Paper for Consideration by ENCWG3**S-52 Presentation Library Issues**

Submitted by:	Chersoft
Executive Summary:	There are a number of issues with the screen shots of ECDIS Chart 1 contained within S-52 Preslib 4.0.2. It is suggested that at least some of the screenshots in the S-52 Part 1 doc have not been generated from the ENC chart 1 transmittal released alongside it.
Related Documents:	S-52 PresLib 4.0.2, ECDIS Chart 1
Related Projects:

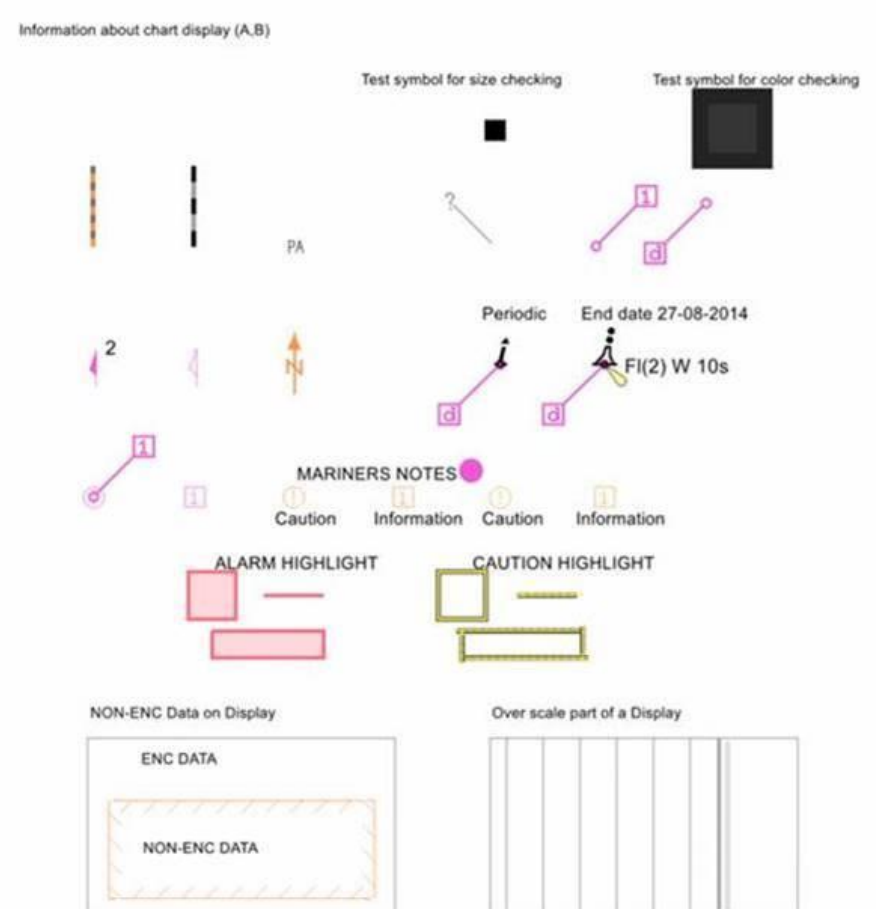
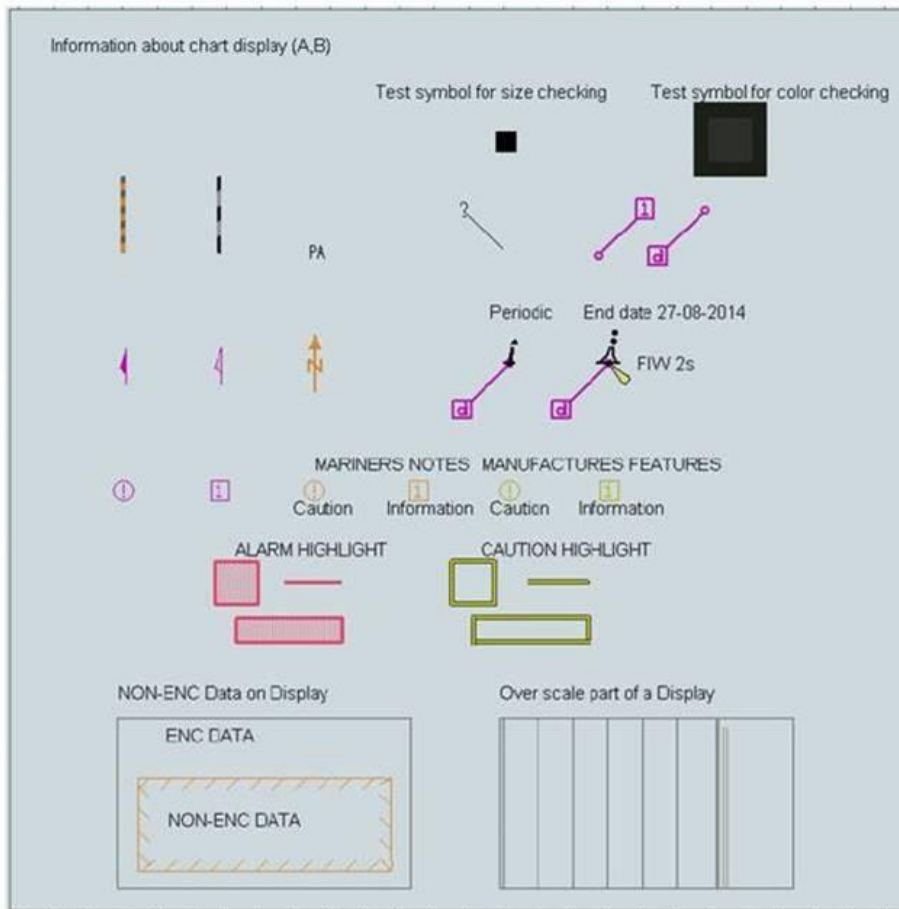
The main issue we have with this cell (AA4C1XMS) is the presence of a M_QUAL feature with CATZOC=3 which covers the whole cell **apart** from the top left dashed rectangle shown in the *Depths, currents, etc.* tile. This dashed rectangle is also a M_QUAL feature but with CATZOC=1. This feature was not present in the transmittal issued with 4.0.1 of the presentation library which I think is what these S-52 screenshots were generated with as the CATZOC=3 feature is not shown, but the CATZOC=1 feature is. There isn't a standard display setting to allow you to draw certain M_QUAL features but not others based on CATZOC value.

In the CherSoft code, we've turned off the viewing group for M_QUAL. If we turn it on, we get the "asterisks in triangle" symbol  drawn all over the cell.

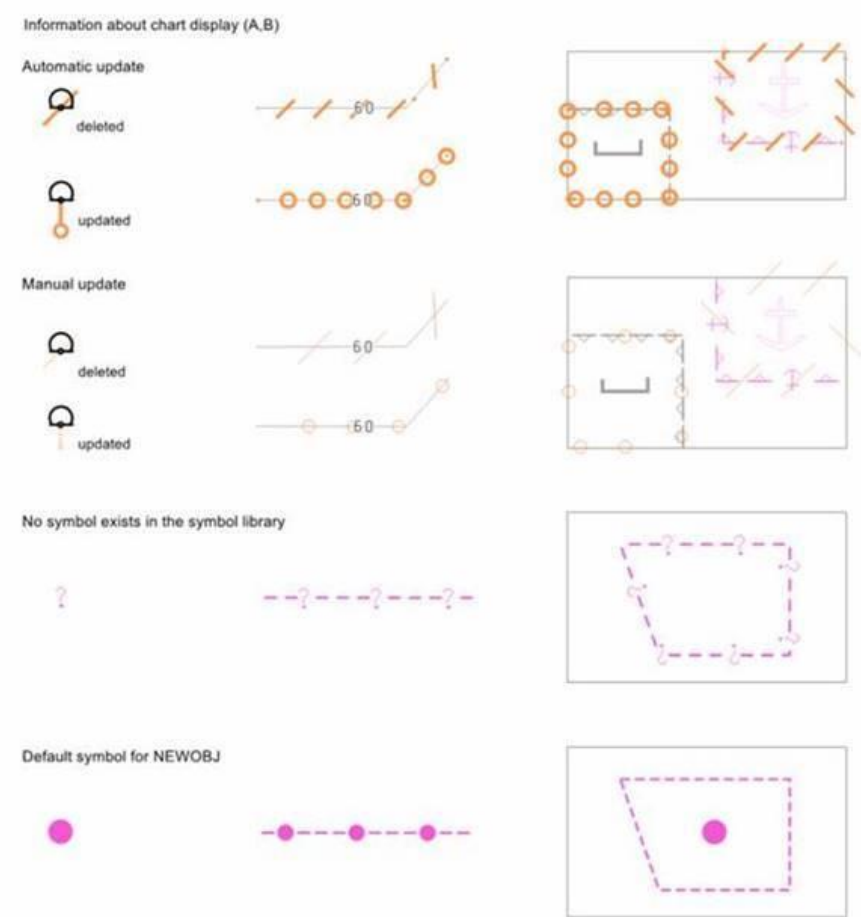
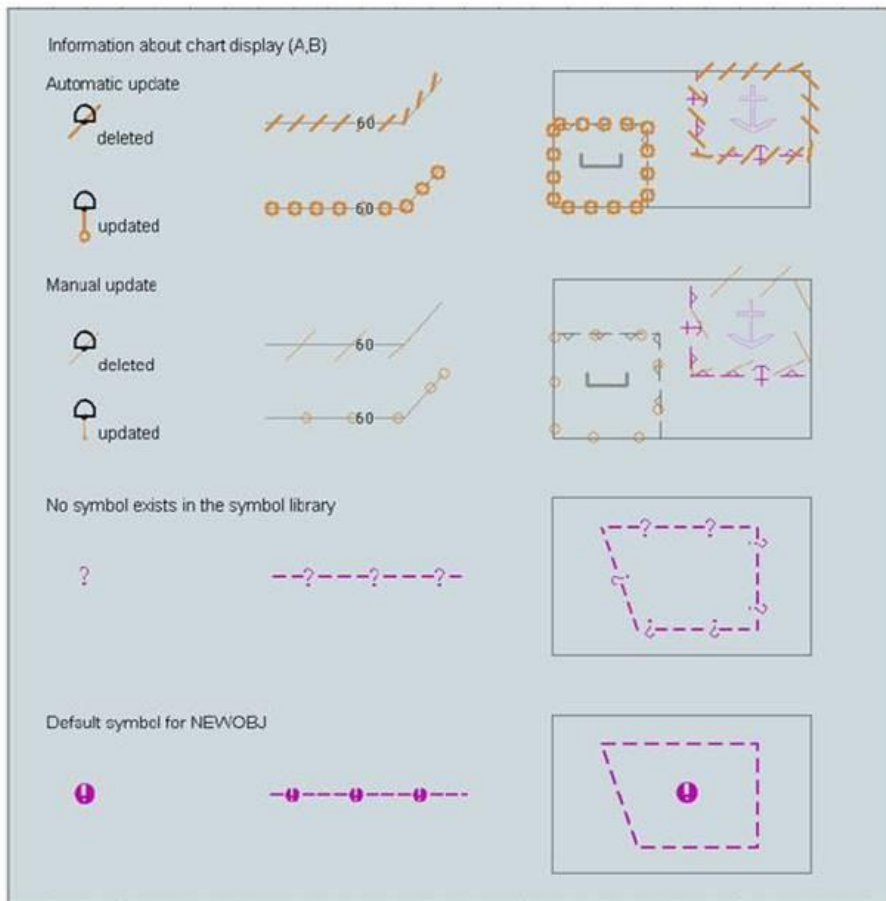
The FIW 2s light characteristic shown in the S-52 screenshot is wrong – it’s actually FI(2) W 10s in the 4.0.2 transmittal.

You might also notice we are not drawing “MANUFACTURES FEATURES”. In the 4.0.2 transmittal, this text is actually “MANUFACTURE’S FEATURES” on the SYMINS attribute of NEWOBJ feature 1810 4127995502 00939. However, this apostrophe causes an issue. The full SYMINS attribute is **TX('MANUFACTURE’S FEATURES',3,2,2,'14109',0,0,CHBLK,11)**. I think most software will struggle to parse this correctly, as the single quotation mark used for the apostrophe is not escaped.

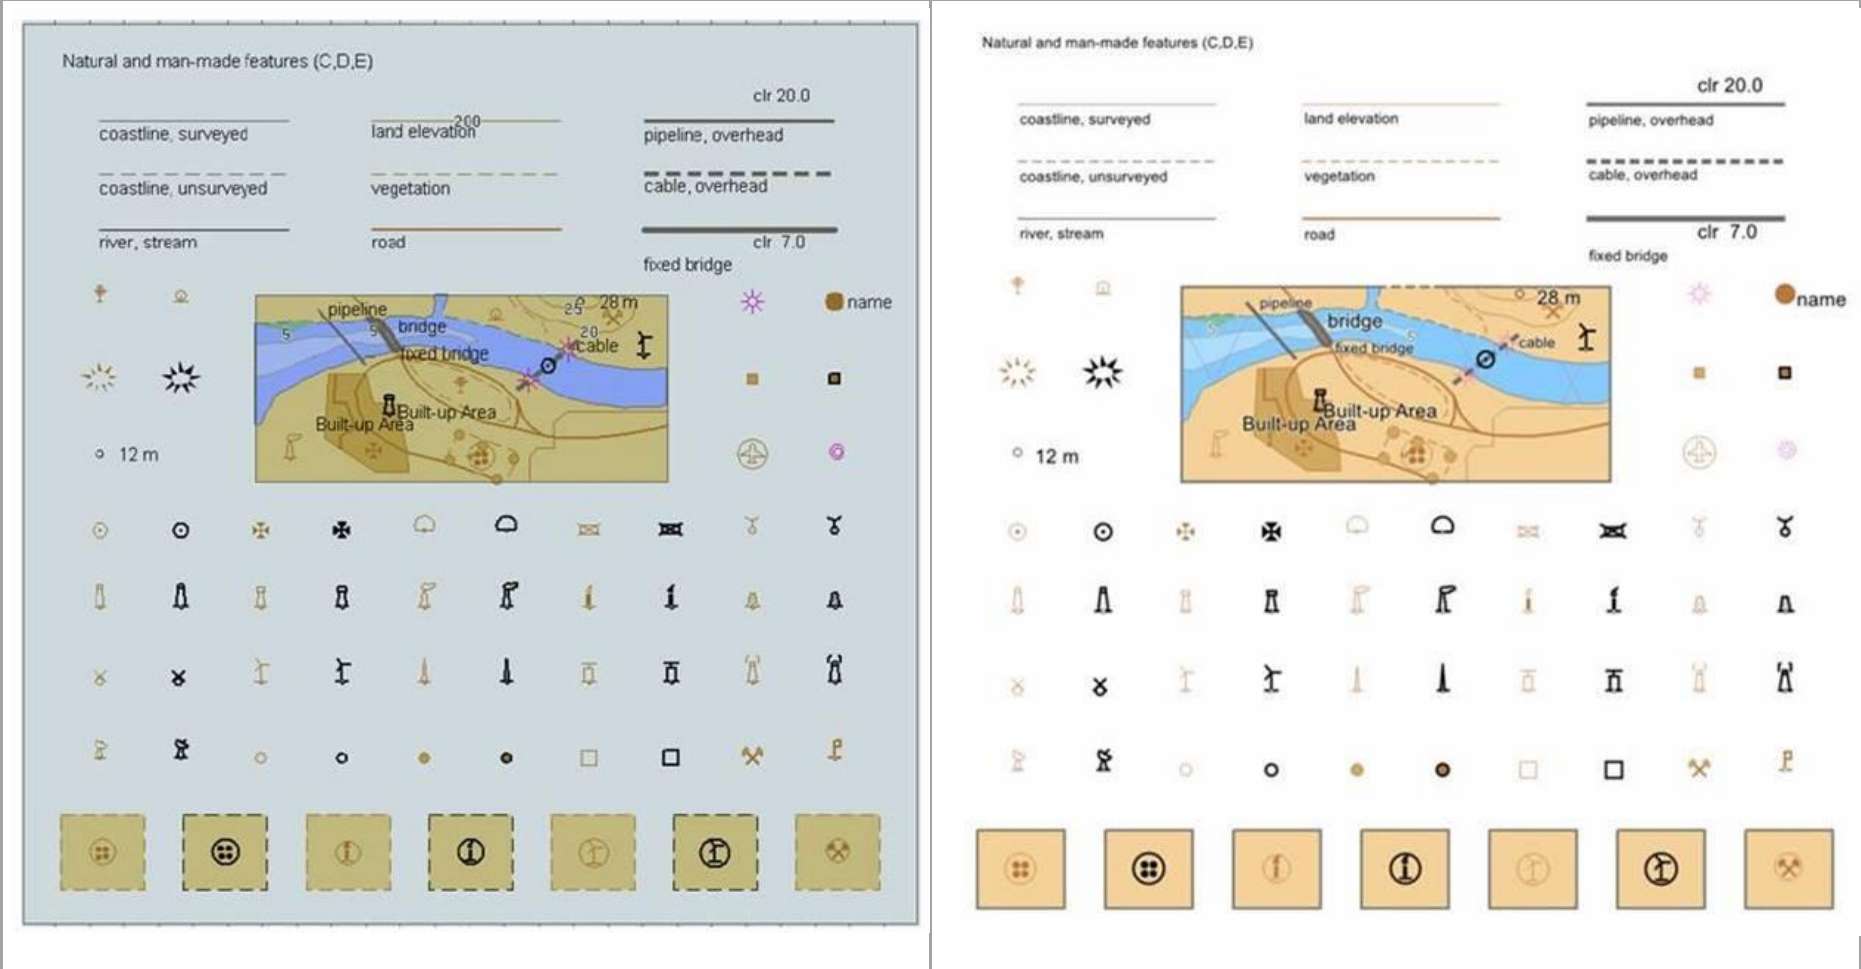
For the CherSoft screenshot, we had to turn Text Group “Value of: magnetic variation; swept depth” off, otherwise swept depths are displayed. This was not necessary for the 4.0.1 transmittal.

More importantly, this cell illustrates a problem in the .dai presentation library file for the NEWOBJ point symbol. You’ll notice we’re missing the exclamation mark from the circle in our rendition. The instruction in the .dai file is:

SPA;SW1;PU300,300;PM0;CI300;PM1;PU250,70;PD350,70;PD350,350;PD250,350;PD250,70;PU300,475;CI60;PM2;FP;

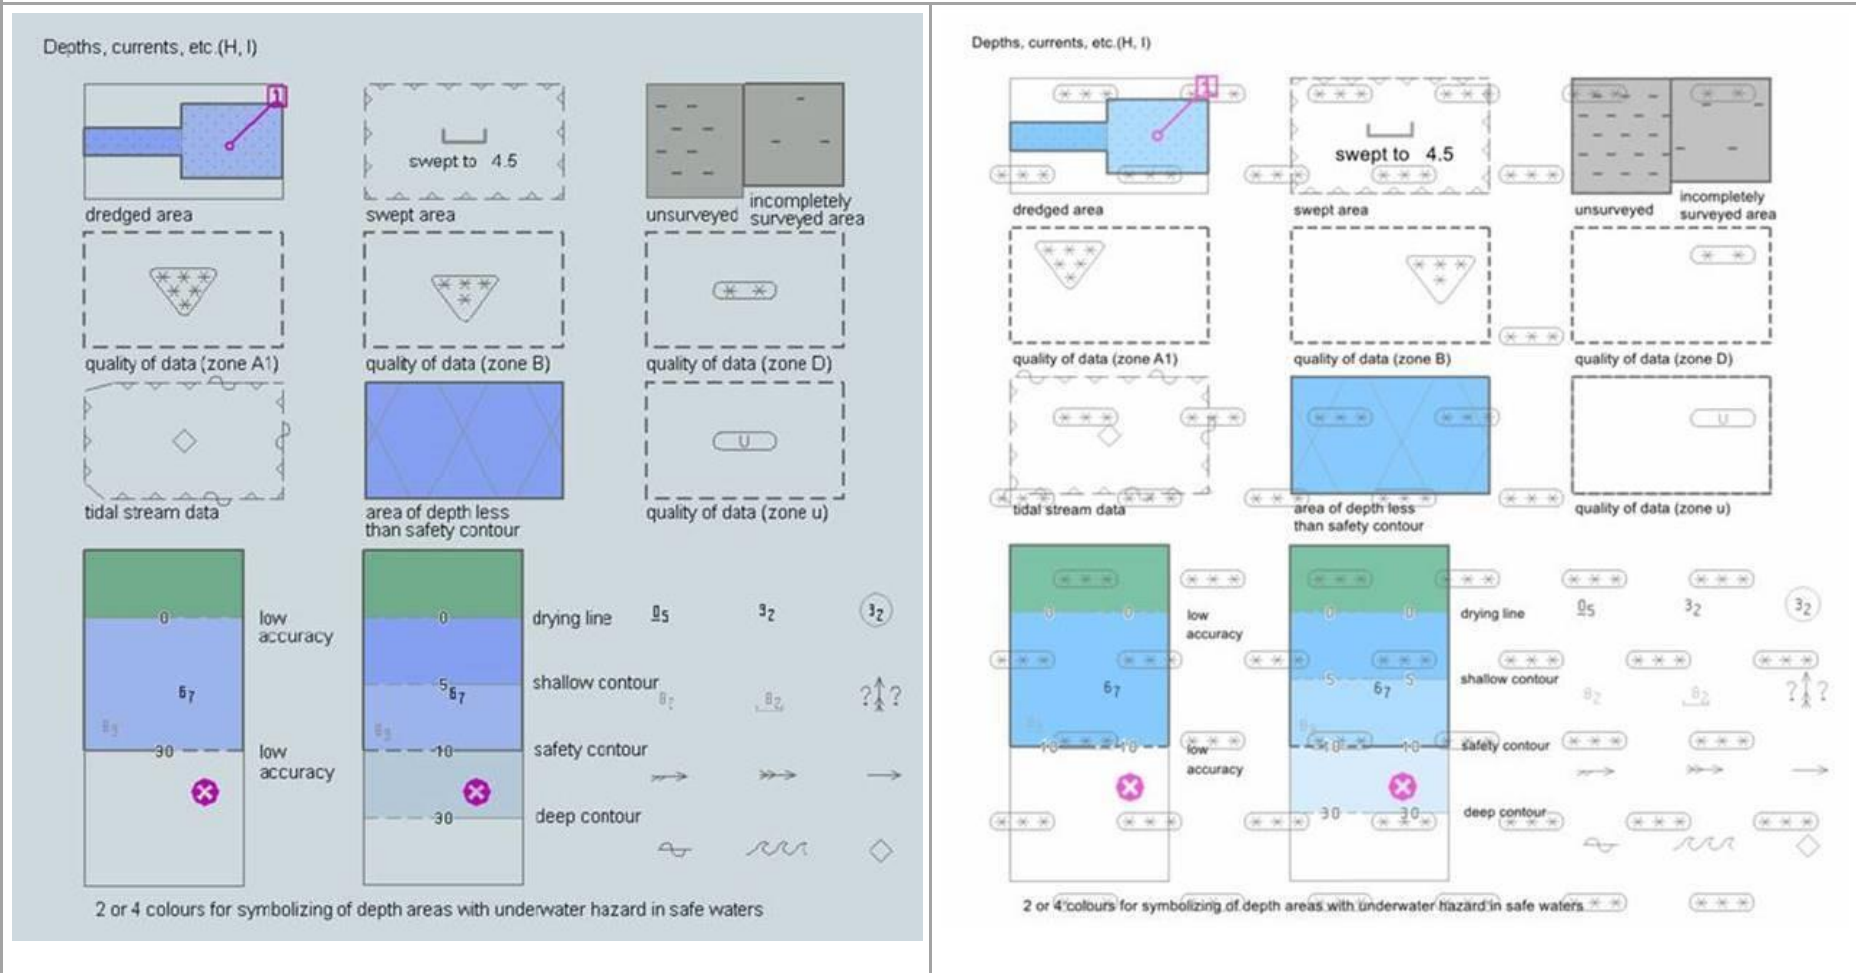
The issue here is that there's one colour instruction at the start (SPA) that sets the pen colour to purple. There's no further colour instruction so we draw the circle and the polygons that make up the exclamation mark in the same colour.

You might notice that in the CherSoft screenshot, we are not showing height contour elevation text for the LNDELV line features. From the .dai file it looks like elevation is only output for LNDELV point features so it's surprising to see it on the S-52 screenshot.

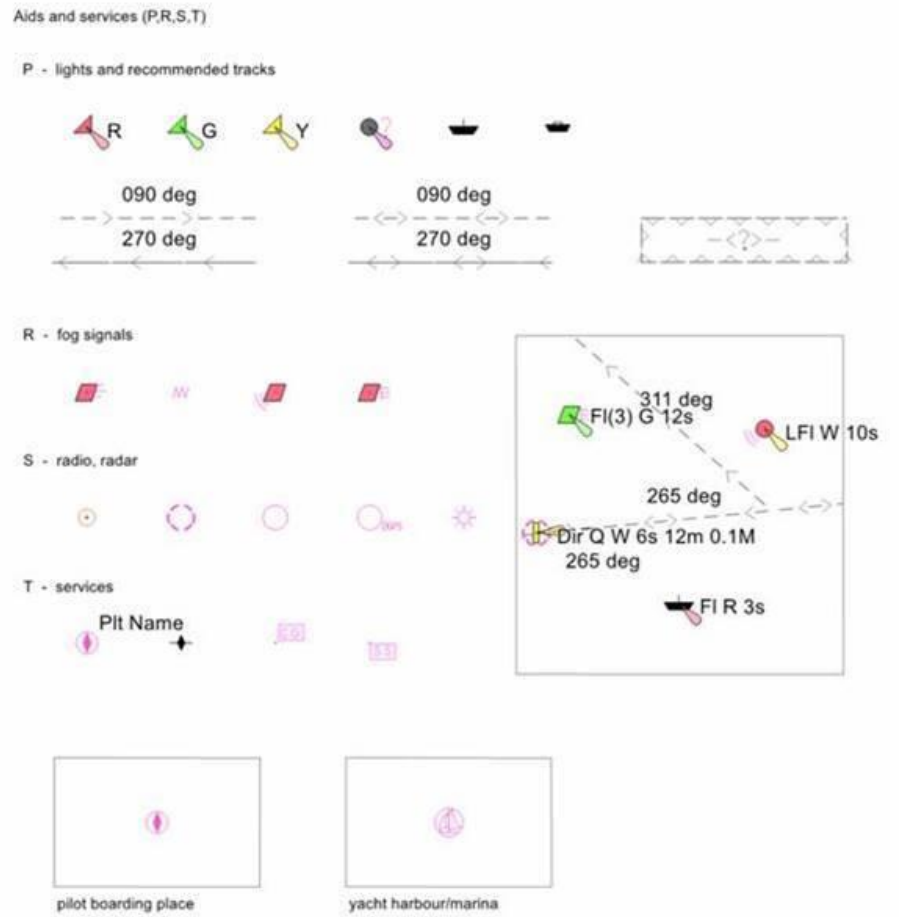
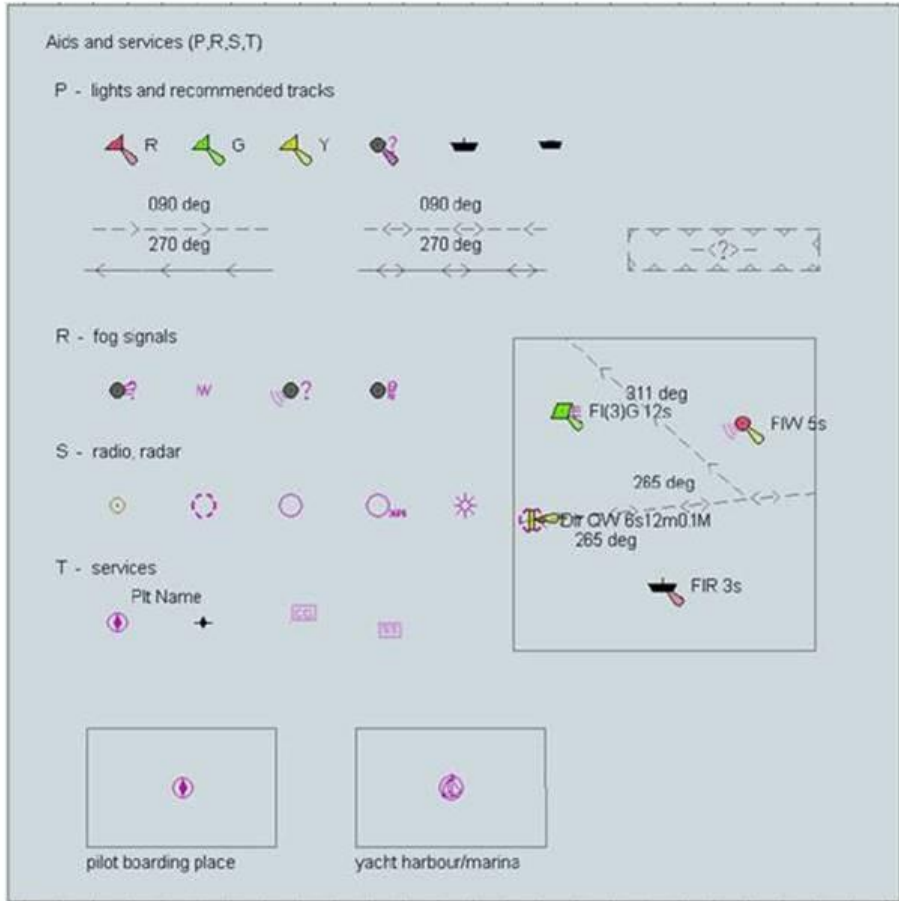
There's a few issues here, but I think the main one is that in the 2 colour depth area symbolisation, the S-52 screenshot shows 30m for the deepest water. I think this is wrong and it should show 10 as that is the depth of the shallower water.

It looks like the symbols used for the fog signals in the S-52 screenshot are just wrong.
